City of Phoenix
PLANNING & DEVELOPMENT DEPARTMENT

Staff Report Z-77-18-6

Self-service storage facility and all underlying C-2 uses with a height waiver to allow up to 3 stories and 35 feet

Northeast corner of 7th Street and Flynn Lane

SITE PLAN

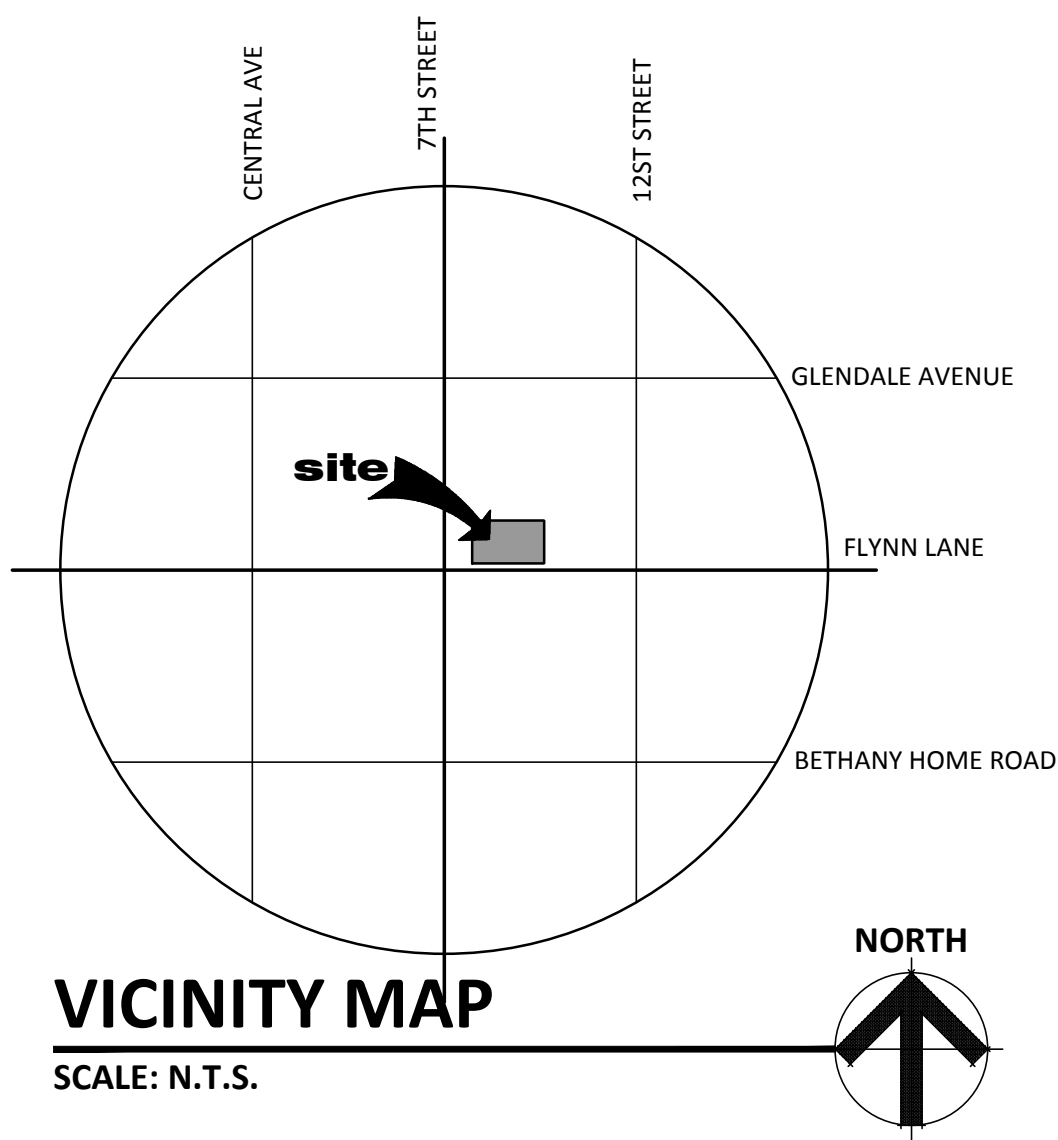
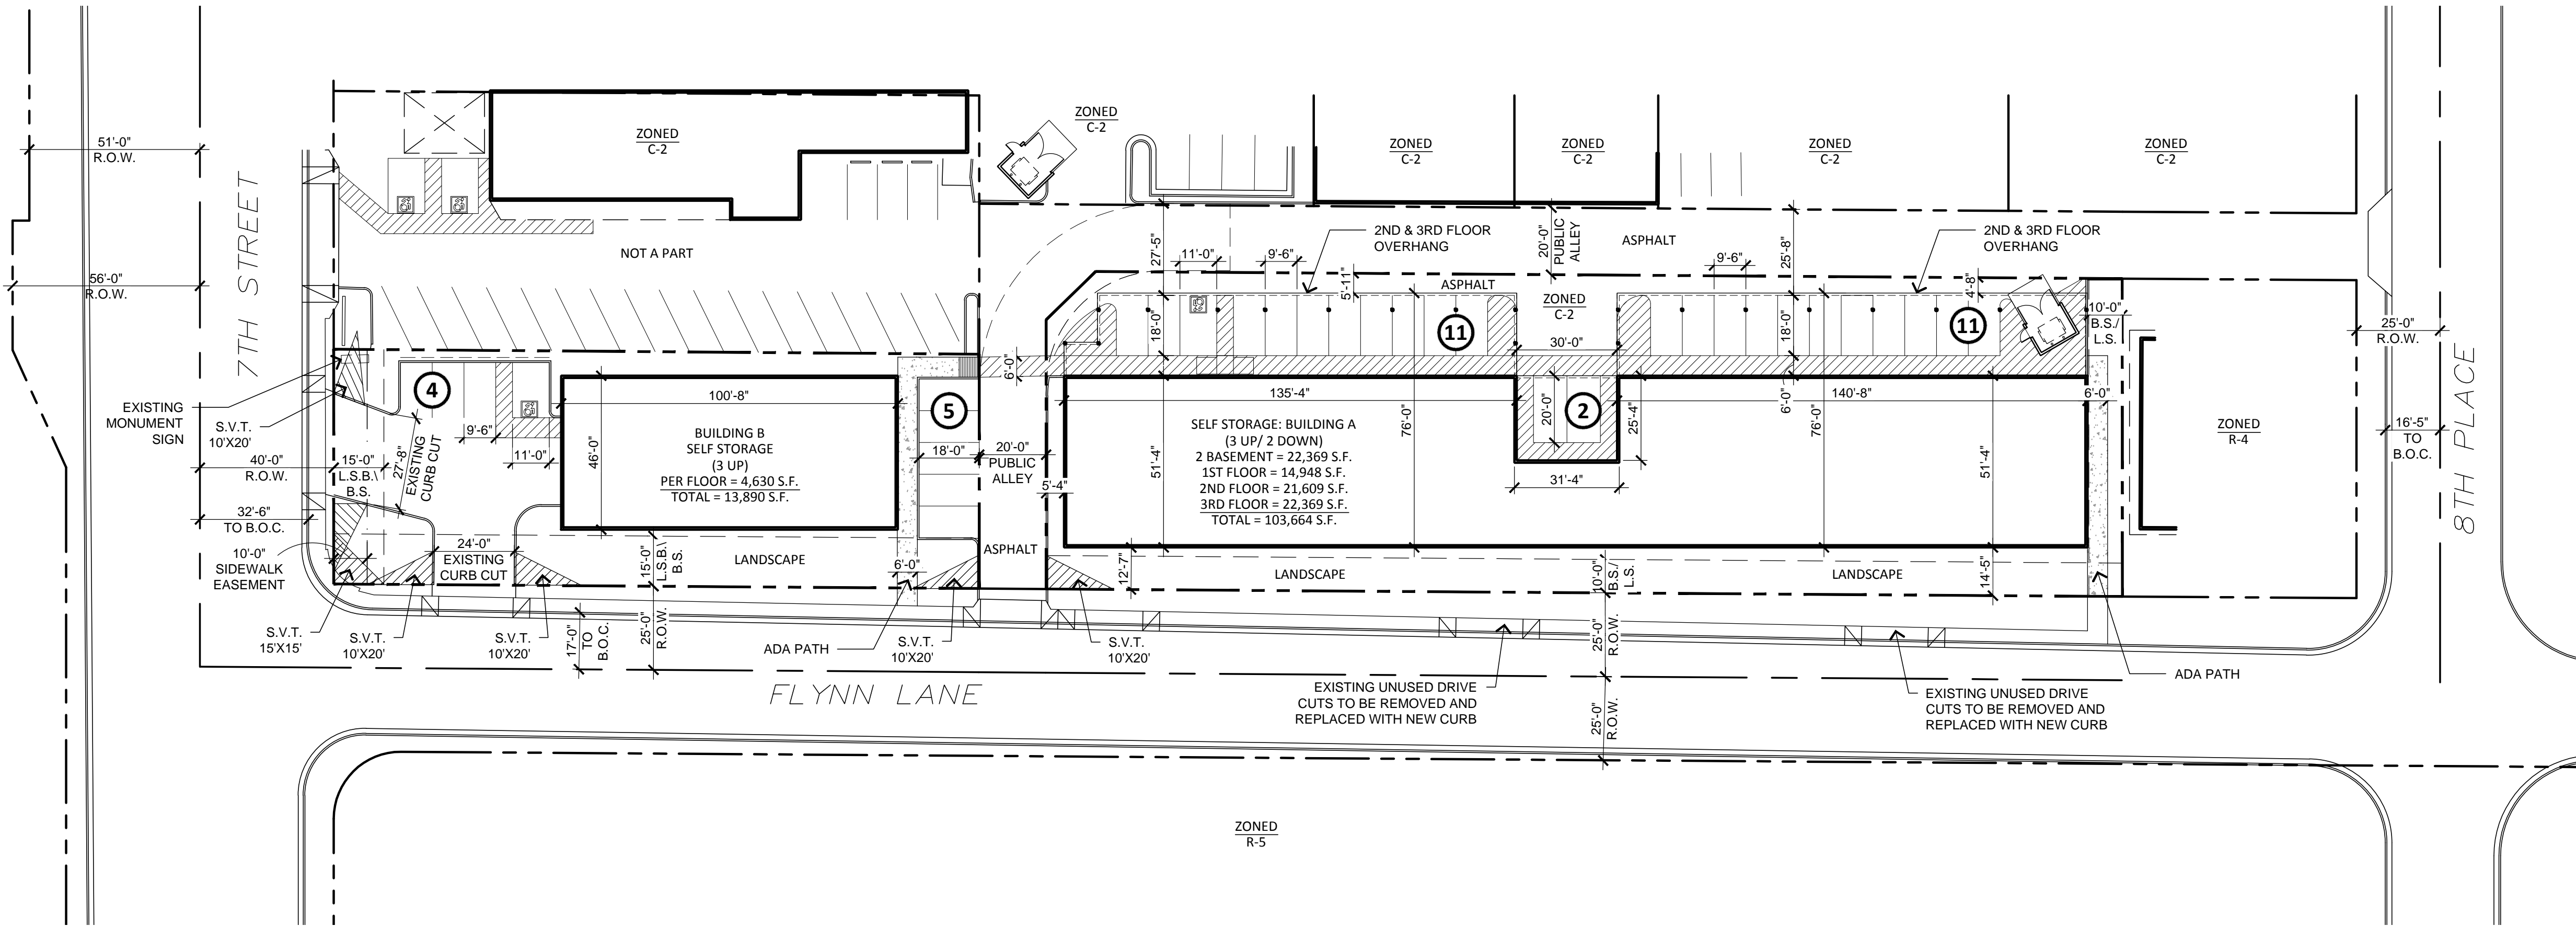
<u>Standards</u>	<u>Requirements</u>	<u>Provisions on the Proposed Site Plan</u>
Building Setbacks		
Adjacent to street, (Flynn Lane and 7th Street)	<p><u>South (Building A and B):</u> For structures exceeding two stories and 30 feet, Average 30-foot setback</p> <p><u>West (Building B):</u> For structures exceeding two stories and 30 feet, Average 30-foot setback</p>	<p><u>South (Building A):</u> 10 feet (not met)*</p> <p><u>South (Building B):</u> 15 feet (not met) *</p> <p><u>West (Building B):</u> 15 feet (not met)*</p>
Adjacent to property line	<u>North (Building A and B):</u> Adjacent to C-2; 0 feet	<p><u>North (Building A):</u> 5 feet (met)</p> <p><u>North (Building B):</u> not provided</p>

Adjacent to property line	<p><u>East (Building A):</u> Adjacent to R-4; 30 feet for building that are 3 stories or 42-feet in height</p> <p><u>East (Building B):</u> Adjacent to alley and C-2 zoning; 0 feet.</p> <p><u>West (Building A):</u> Adjacent to Alley and C-2 zoning; 0 feet</p>	<p><u>East (Building A):</u> 10 feet (not met)*</p> <p><u>East (Building B):</u> 24 feet (met)</p> <p><u>West (Building A):</u> 5 feet (met)</p>
Landscape Setbacks		
Adjacent to street, (Flynn Lane and 7th Street)	<p><u>South (Building A and B):</u> Minimum 20 feet for up to 50% of the frontage, average 30 feet for structures exceeding two stories and 30 feet in height.</p> <p><u>West (Building B):</u> Minimum 20 feet for up to 50% of the frontage, average 30 feet for structures exceeding two stories and 30 feet in height.</p>	<p><u>South (Building A):</u> 10 feet (not met)*</p> <p><u>South (Building B):</u> 15 feet (not met)*</p> <p><u>West (Building B):</u> 15 feet (not met)*</p>

*The site shall be modified to meet the requirement or a variance shall be obtained.

5. The conceptual site plan proposes two self-service storage facilities on separate parcels. The project will be phased with anticipation that the eastern parcel, Building A, be developed first. The eastern parcel depicts a three story building with two basements, totaling 103,664 square feet with access along Flynn Lane and 8th Place, through a commercial alley to the north. In regard to access to Building A, the applicant would be required to obtain a variance to access the site from Flynn Lane and 8th Place because the special permit district standards for self-service storage facilities require that the site have direct access from an arterial street. The applicant would also be required to obtain a variance to allow maneuvering in the alley. If this is not feasible, the applicant may pursue a cross access agreement and abandonment of the commercial alley. The request makes no modifications to the existing access to and from the site. Covered parking is provided along the north of the building.

The western parcel, containing Building B, depicts a three story building, totaling 13,890 square feet with access from 7th Street and Flynn Lane. Building B has direct access off of a major arterial street and therefore requires no further entitlements to access the site. Parking for the facility is proposed along the eastern property line. Staff has recommended that the uncovered surface parking lot area be landscaped with a minimum 2-inch caliper shade trees that are dispersed throughout. Trees within surface parking lot area will help reduce the urban heat island effect and will provide thermal comfort for guests going to and from their vehicles. This requirement is addressed in Stipulation No. 6.

1. The maximum building height shall be 3 stories and 33-feet.
2. The development shall be in general conformance with the elevations date stamped January 22, 2019, as approved by the Planning and Development Department.
3. A minimum of one inverted-U bicycle rack (two spaces) for guests or employees shall be provided on site and installed per the requirements of Section 1307.H of the Zoning Ordinance, as approved by the Planning and Development Department.
4. The sidewalk along Flynn Lane shall be detached with a minimum 5-foot wide landscape strip located between the sidewalk and back of curb and shall include a minimum 2-inch caliper

6. All required landscape areas within the uncovered portion of the surface parking lot shall be landscaped with a minimum 2-inch caliper shade trees. Landscaping must be dispersed throughout the parking area, as approved by the Planning and Development Department.
